**METROPOLITAN DEVELOPMENT COMMISSION
REGIONAL CENTER HEARING EXAMINER**

STAFF REPORTS FOR DECEMBER 15, 2022

STAFF REPORT

Case Number	2022-REG-067
Address (approx.)	675 East Washington Street
Location	Center Township, Council District # 16
Petitioner	Global Indy III, LLC, by Jamilah Mintze
Zoning	I-3 (RC)
Request	Regional Center Approval to provide for a 10,000-square-foot building addition to an existing 85,000-square-foot building and minor façade improvements. Existing windows, glass block, brick veneer and main entry would remain.

Site plan

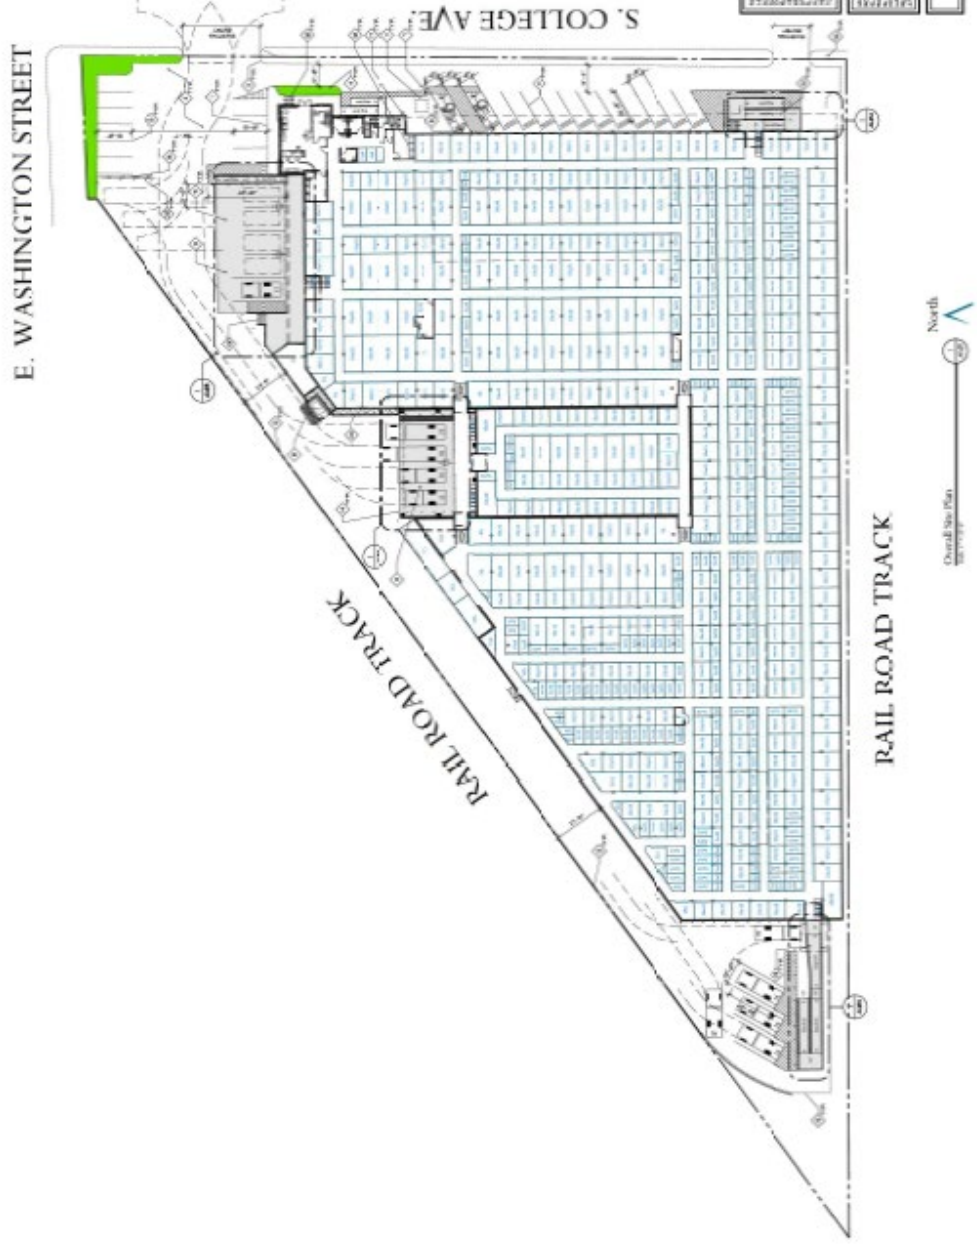
3. A landscape plan was not submitted with this request. Staff proposes that new landscaping be added along College Avenue and at the corner of College Avenue and Washington Street. A landscape plan shall be submitted and subject to planning staff review and approval, prior to the issuance of an Improvement Location Permit. These Guidelines shall be reviewed in formulating the landscape plan: US 1.3.2, SC 3.4.2, CA 4.4.3, CA 4.6.1, CA 4.6.2, and CA 4.6.4.

Elevations

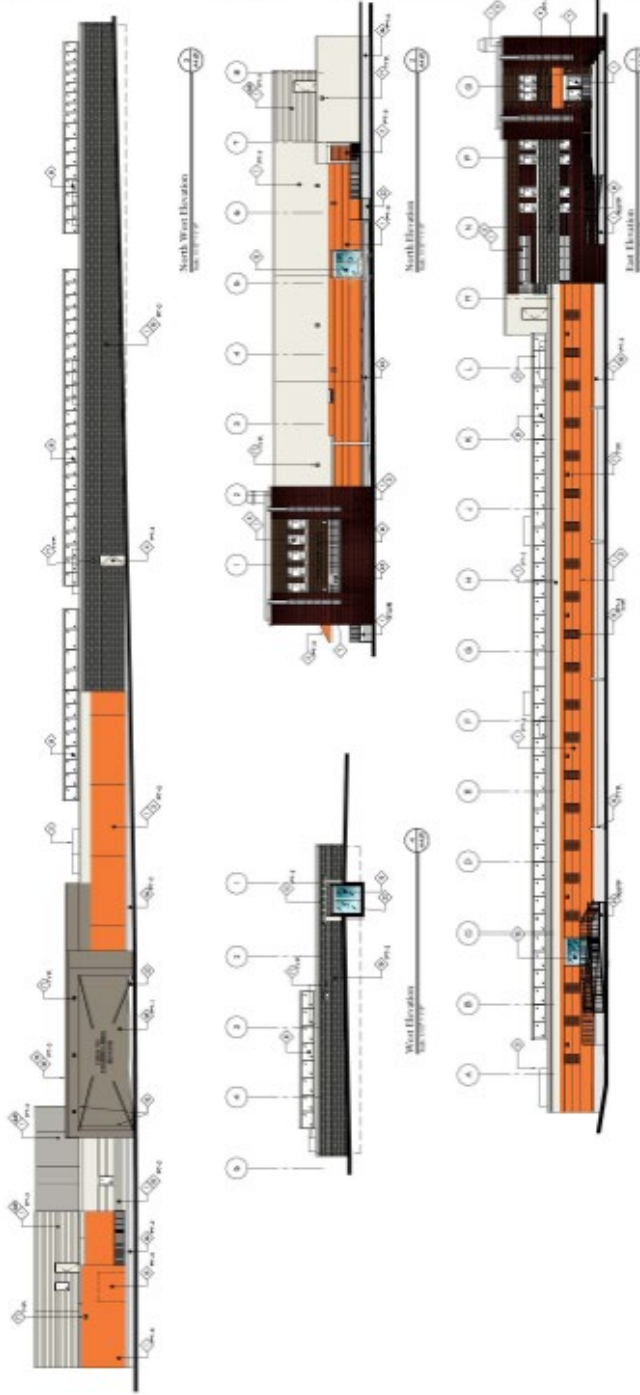
2. The following Guidelines relate to site buffers and building character, including paint colors: US 1.2.1, US 1.2.3, SC 2.1.1, CA 1.2.4, CA 2.1.1, CA 2.1.2, CA 2.2.1, CA 2.2.2, CA 2.3.1, and CA 2.3.4. The existing loading dock on the north side of the building would be visible from College Avenue, especially when trucks are being loaded and unloaded. Staff proposes that a masonry wall be constructed to shield the loading area from view of the public way and that this wall shall be tall enough to shield a typical rental truck. Additionally, the chosen paint color is too bright and should be toned down. Staff proposes that the color of the upper-most brick color on the two-story portion of the building, be used as a guide to finalize a paint color. This paint should also not cover the entire building along the public way. Staff has no issues with using the bright orange color for awnings or canopies. A photo of the brick to use as a guide is below. A revised elevation plan noting the above recommendations shall be submitted and subject to planning staff review and approval, prior to the issuance of an Improvement Location Permit.
